SERVICE BULLETIN # 00093

SUBJECT: Converting Merlin From English To French Language

MODELS: Merlin 2000 Venders with Control Board Revision 5.09C and Above

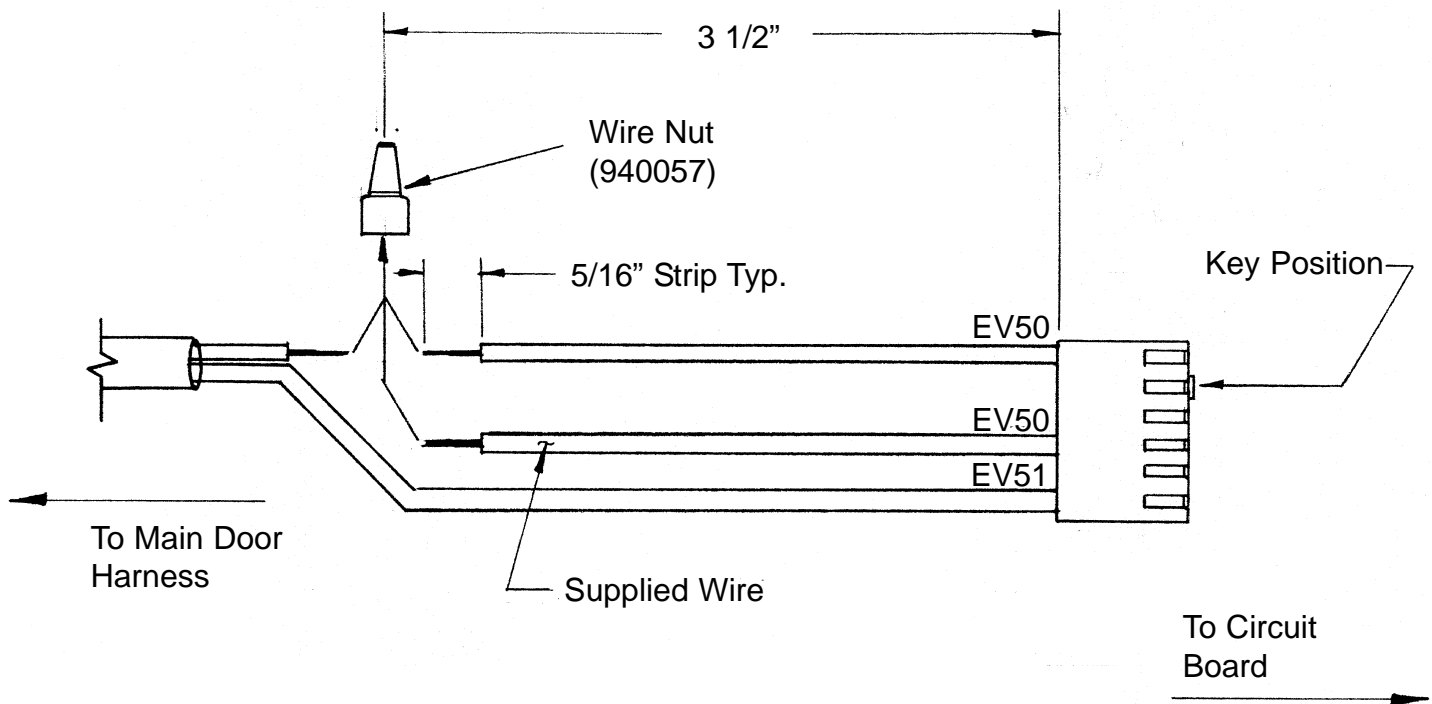
1. Turn power off to vender.
2. Remove circuit board cover and locate option receptacle on control board.
3. Remove option receptacle from board. Push tubing surrounding wires back into main harness tubing. Locate wire EV50. Cut wire EV50 approximately 3 1/2" from receptacle. Strip both ends cut approximately 5/16". Using supplied wire EV50 and wire nut (940,057,011) supplied with kit, splice all (3) wires together.
4. Insert terminal side of supplied EV50 wire into position 4 of option receptacle.
5. Slide tubing back into position.
